## STAFF REPORT

**TO:** Lake Elmo City Council  
**FROM:** Nathan Fuerst, Consulting Planner  
Jenni Faulkner, Consulting Planner  
**AGENDA ITEM:** Final Plat/Planned Unit Development – Amira (United Properties)

Re: Amira of Lake Elmo (United Properties)  
Construction Plan Review

Project 19.1001.04 Drawing Number  
Date 05/05/2023  
Drawn by BAW C400  
Checked by JFJ

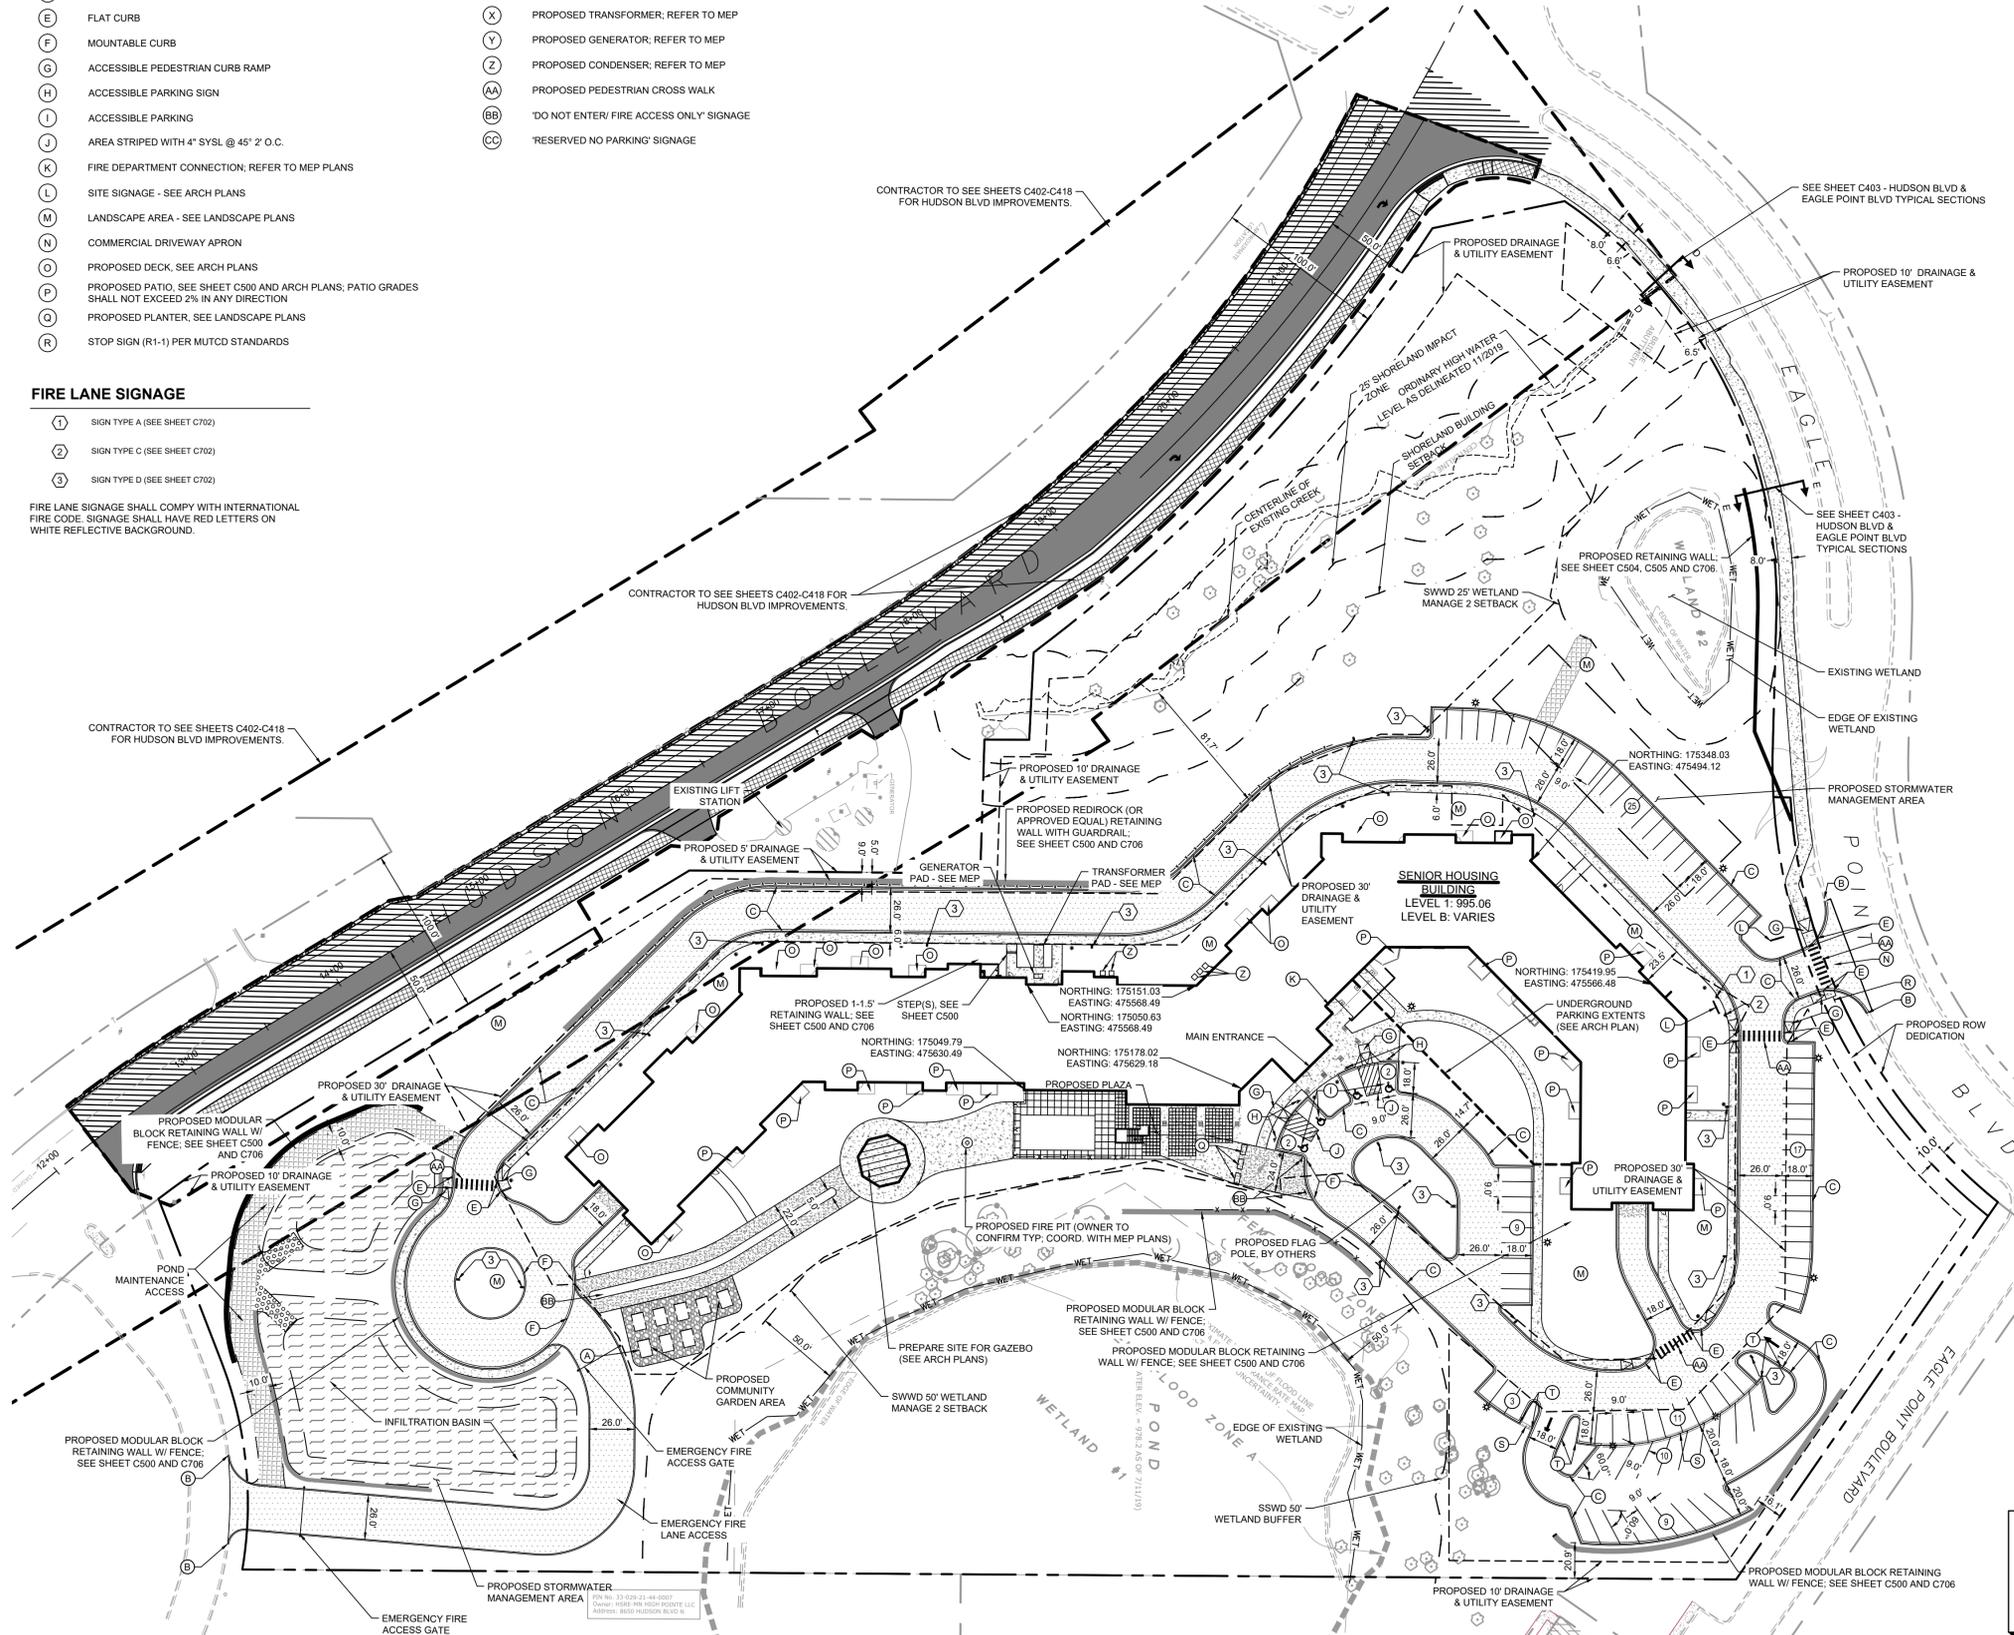
7. C302. Add City Standard Plan Notes (details 600A, 600B, 600C and 600D).
8. C400. Revise the site plans to clearly depict the Emergency Access Easement Area per the Emergency Access Easement Agreement.
